MIL-M-22179(AS)  
Amendment-6  
15 August 1969  
Superseding  
Amendment-5  
27 November 1968

MILITARY SPECIFICATION

MICROPHONE, DYNAMIC M-96B/A

This amendment forms a part of Military Specification MIL-M-22179(WEP) dated 1 May 1961 and has been approved by the Naval Air Systems Command, Department of the Navy.

Figure 1. Outline Dimensions and Markings of  
Microphone and Boom M96B/A

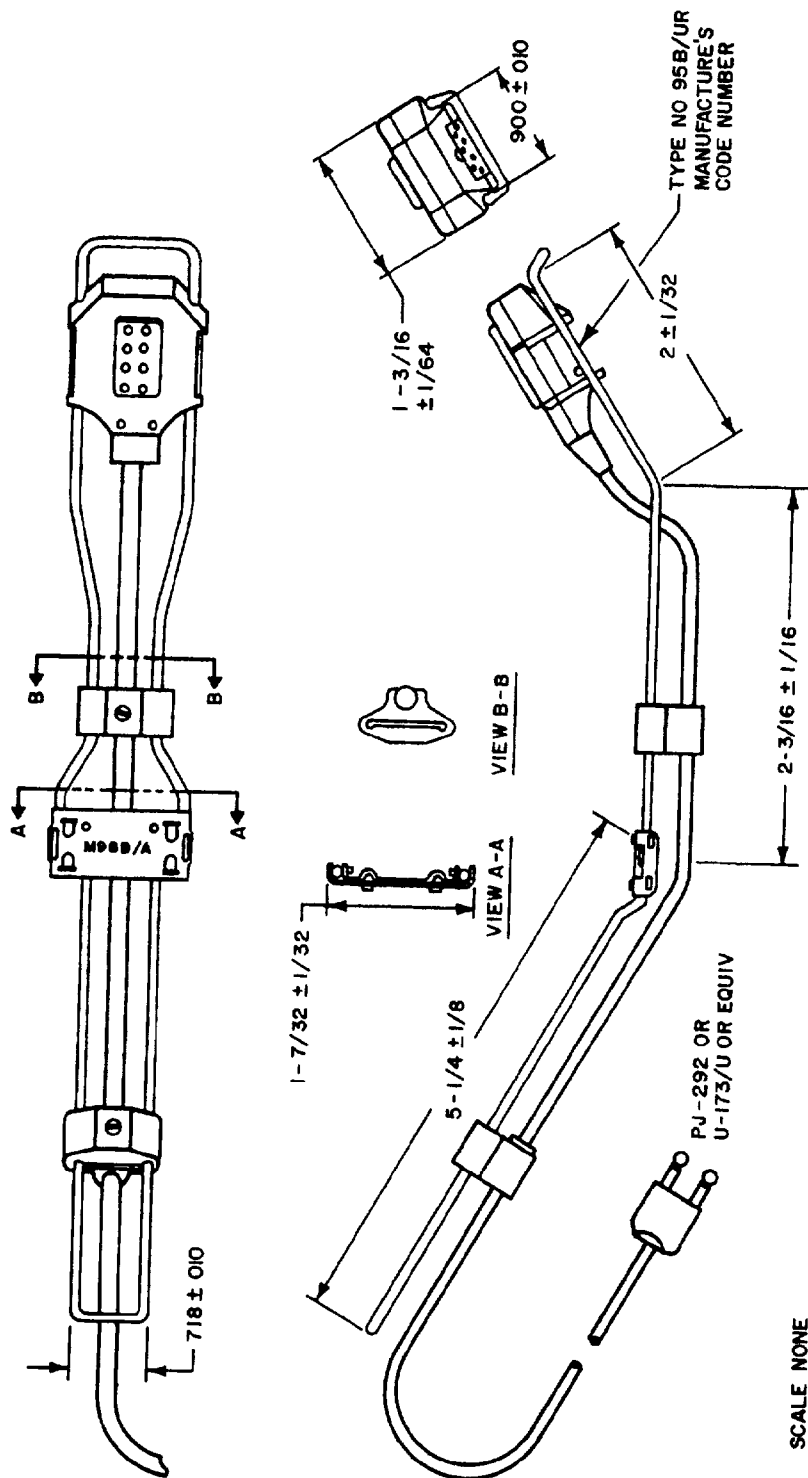
- \*Page 5, paragraph 3.4.1.3.2.1: Add "and 1A."
- \*Page 5, paragraph 3.4.1.3.2.2: Delete "(Figure 1), WD-27/U" and "MIL-C-10392" and substitute "(Figure 1 and 1A), WD-34/U" and "MIL-C-25662" respectively.

Pages 17  
and 19, Figures 1 and 3: Delete and substitute the new figures 1, 1A, and 3, of this amendment.

Figure 4. Standard Test Circuit.

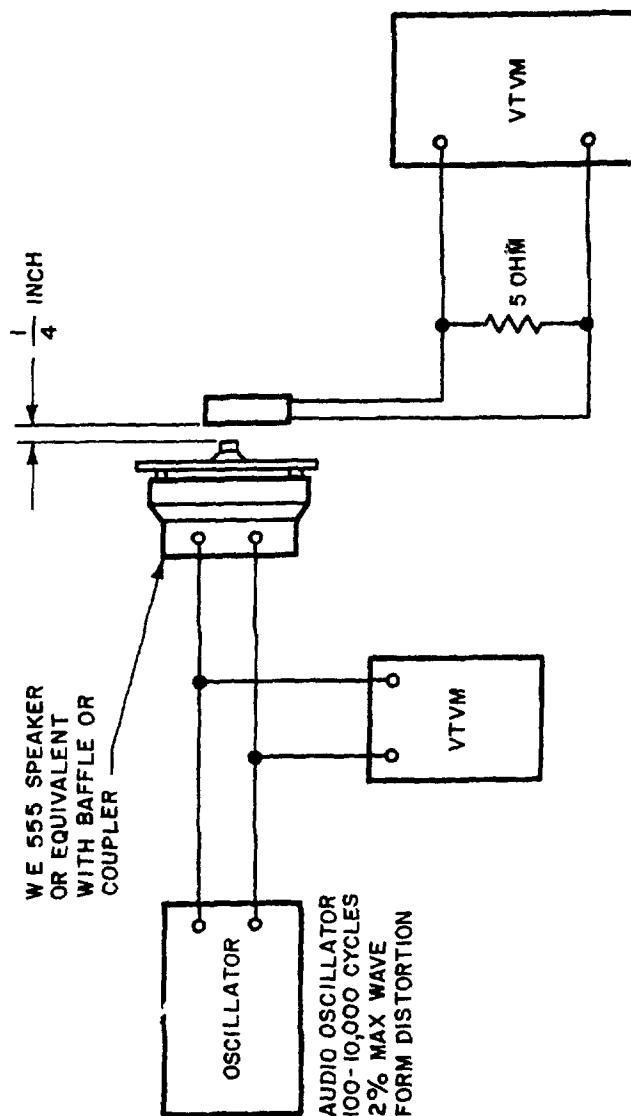
Page 13: Add  
"4.5.13 Distortion - The distortion of the microphone shall be measured for compliance with requirements of 3.5.4 by using a distortion analyzer connected across the 5.0 ohm resistor of Figure 4."

Page 20, Figure 4: Delete and substitute the new Figure 4 of this amendment.

FIGURE 5. TEST BASE ASSEMBLY

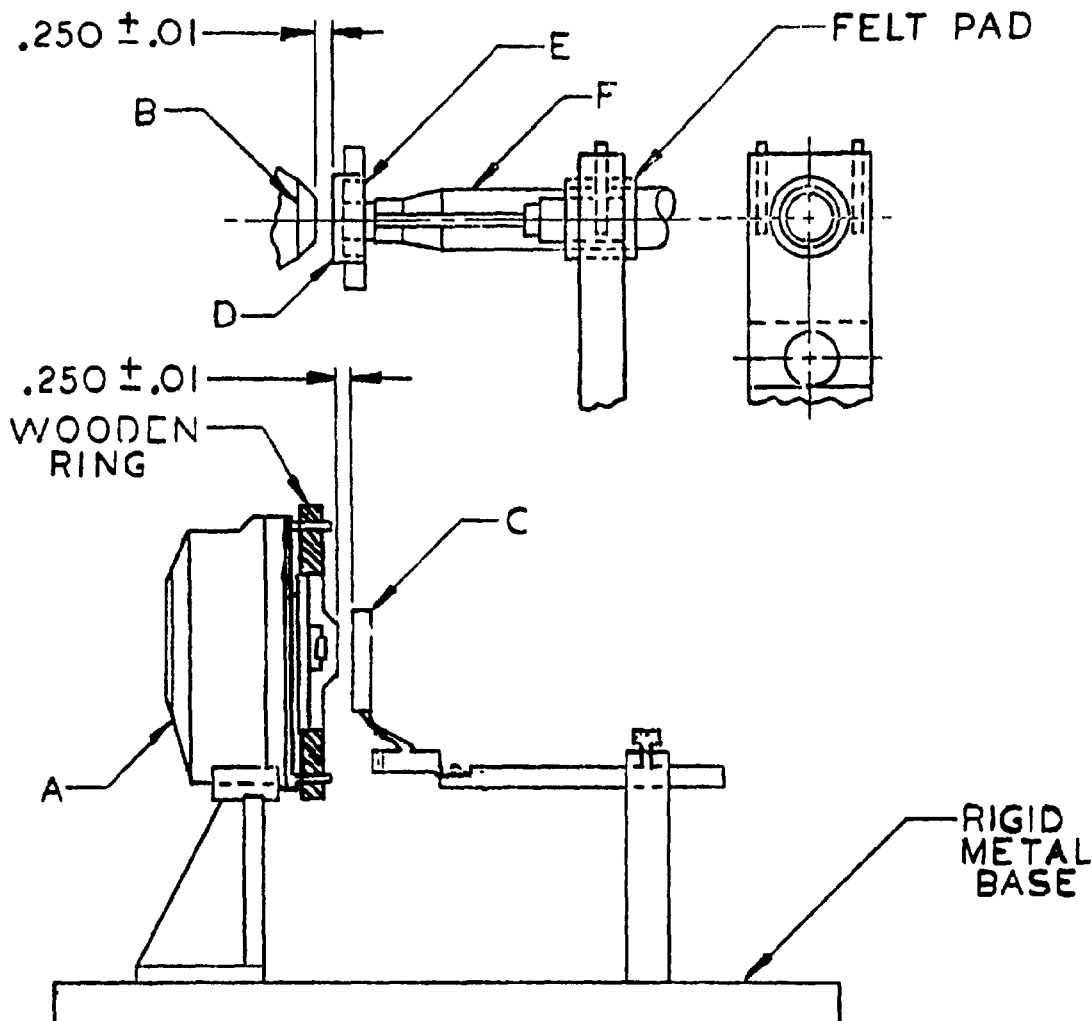
- Page 11, paragraph 4.5.2: Delete and substitute  
"4.5.2 Test Calibration Procedure - The condenser microphone shall be mounted as shown in Figure 5 with an air gap of 1/4 inch separating the coupler and the microphone grid. The microphone axis shall coincide with the center line of the

Page 21, Figure 5: Delete and substitute the new Figure 5 of this amendment.

Figure 8. Signal to Noise Ratio Test Circuit.

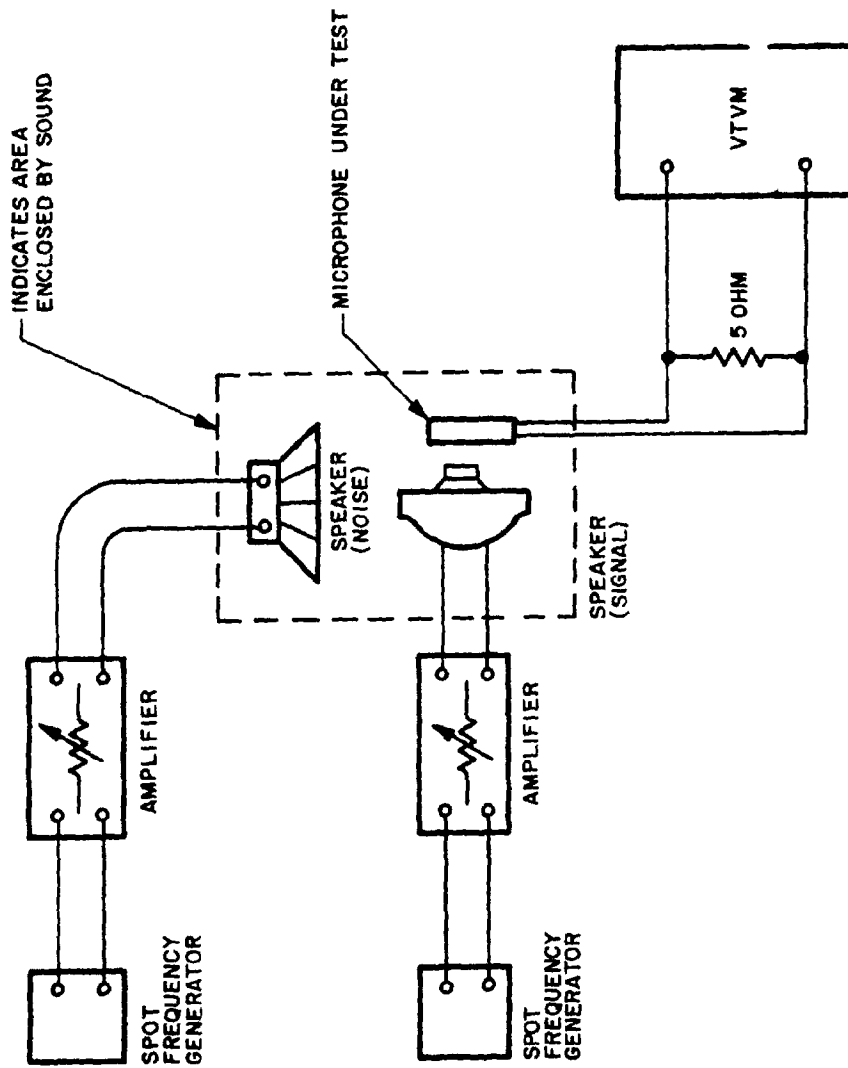
Page 24, Figure 8: Delete and substitute the new Figure 8 of this amendment.
